CONVAIR

COMMERCIAL CHANGE PROPOSAL

SPEC NO.: ZD-22-327 DATE: _____
 CUSTOMER: JAL MCL 15,037 DTD _____
 CHANGE NO: 93 MODEL: 22-3 (22M)

TITLE: Specification Administrative Change (Revision to Portable Oxygen Bottle Part Number - Group C Airplanes)

Page 7a, C. G. DESIGN LIMITS:

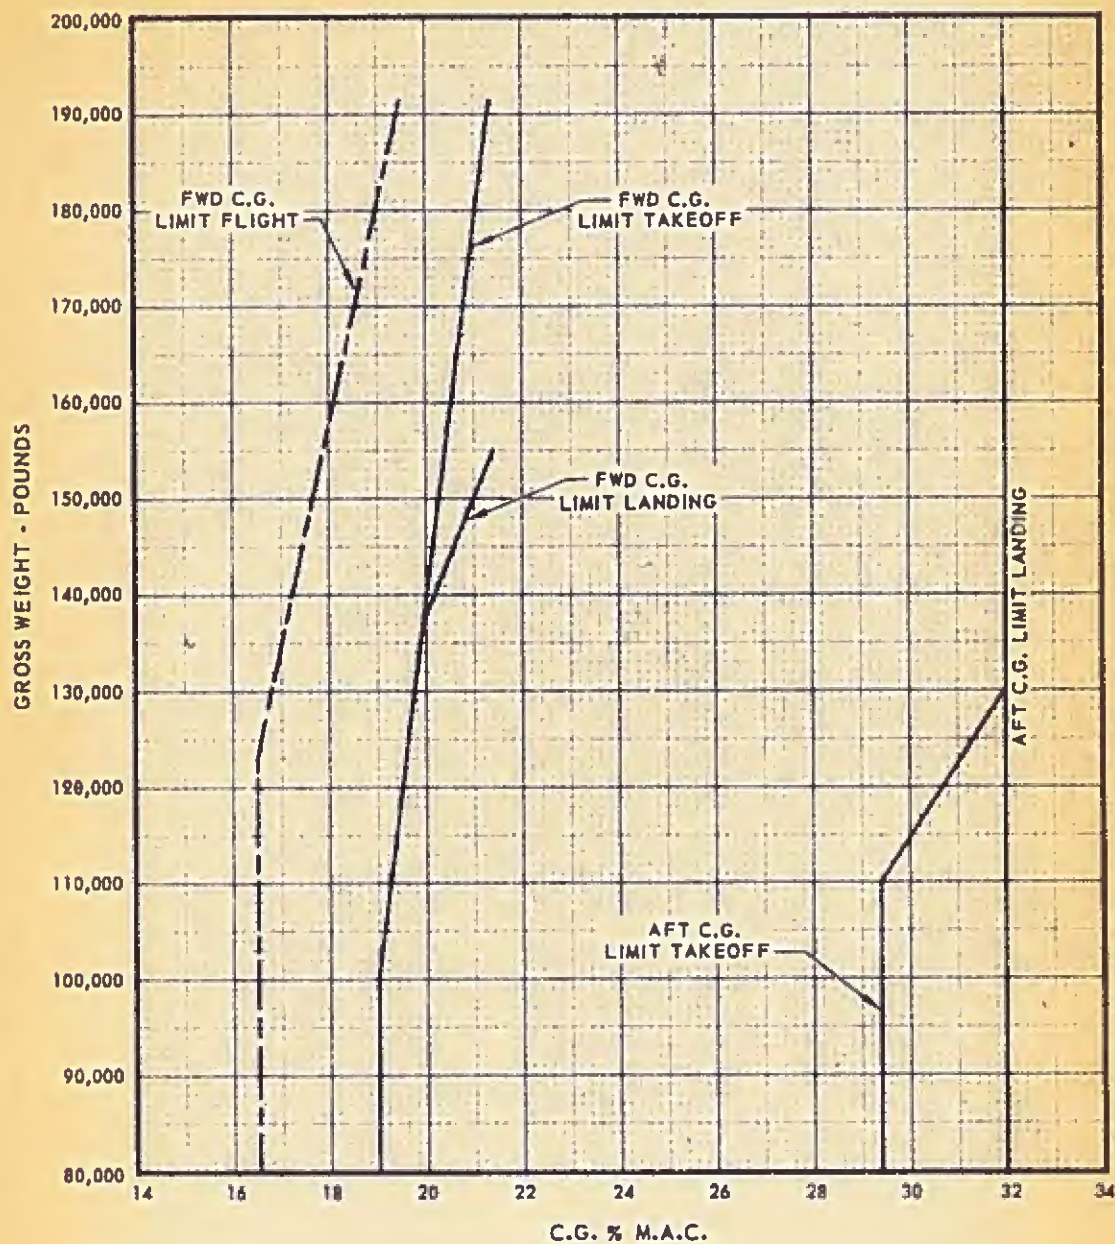
Reason for Change: To furnish an up to date C. G. Limits Graph.

Page 44b, PILOT'S AND COPILOT'S PEDESTAL:

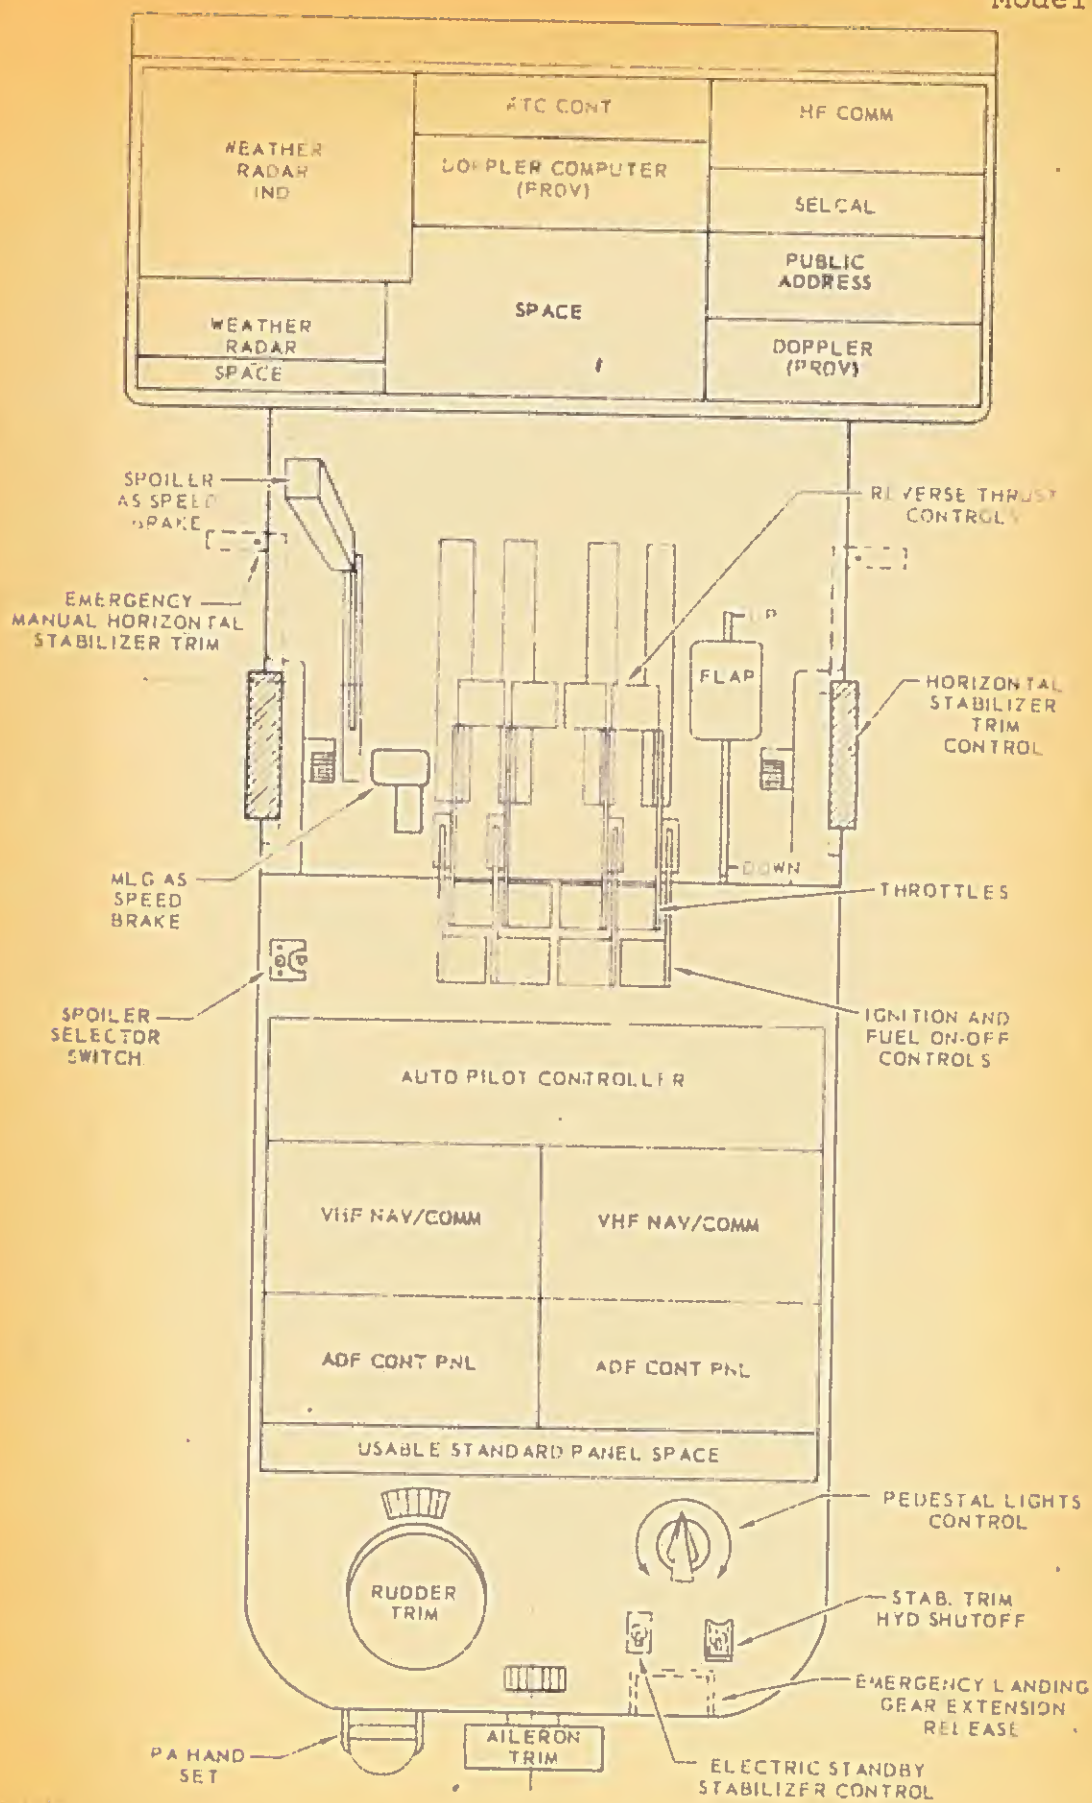
Replace above illustration in the specification with Enclosure (B), which deletes "MALFUNCTION LIGHTS".
